UNITED STATES
NUCLEAR REGULATORY COMMISSION
WASHINGTON, D. C. 20555

November 30, 1981

Amdt. 105
to DPR-47

These amendments revise the TSs to allow full power operation of Unit 1 for fuel Cycle 7, reflect completed modifications to the high pressure injection system and revisions to the boron concentration requirements.

CORE PROTECTION
SAFETY LIMITS
UNIT 1
OCONEE NUCLEAR STATION
Figure 2.1-2A

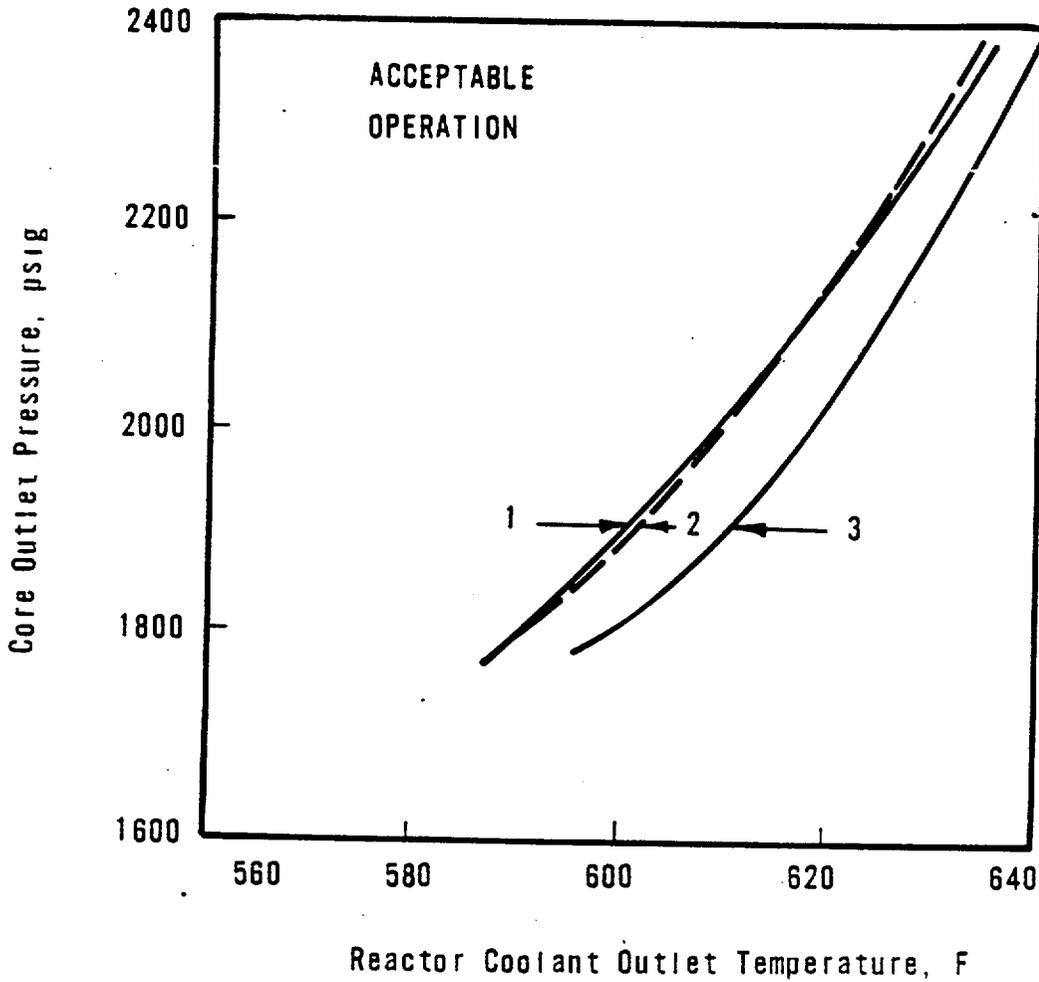
The curves of Figure 2.1-2A are based on the more restrictive of two thermal limits and include the effects of potential fuel densification and rod bowing:

The specified flow rates for Curves 1, 2, and 3 of Figure 2.1-2A correspond to the expected minimum flow rates with four pumps, three pumps, and one pump in each loop, respectively.

PROTECTIVE SYSTEM MAXIMUM ALLOWABLE SETPOINTS
 UNIT 1
 OCONEE NUCLEAR STATION
 Figure 2.3-2A

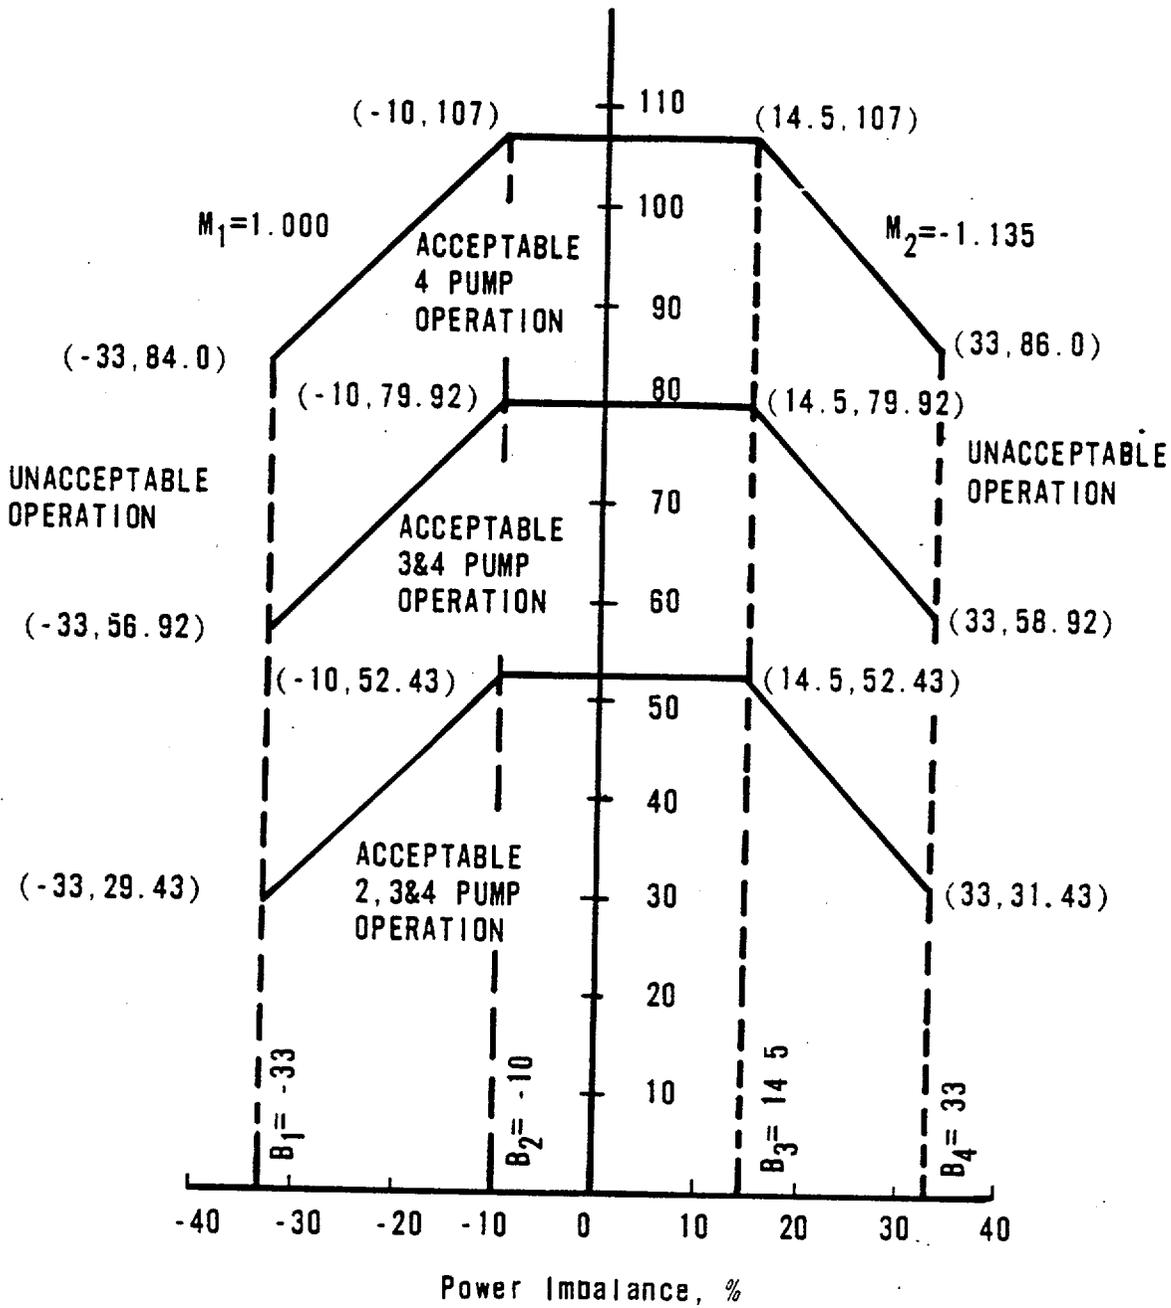
The power-imbalance boundaries are established in order to prevent reactor thermal limits from being exceeded. These thermal limits are either power peaking kw/ft limits or DNBR limits. The reactor power imbalance (power in the top half of core minus power in the bottom half of core) reduces the power level trip produced by the power-to-flow ratio such that the boundaries of Figure 2.3-2A - Unit 1 are produced. The power-to-flow ratio reduces the power

level trip and associated reactor power/reactor power-imbalance boundaries by 1.07% - Unit 1 for 1% flow reduction.
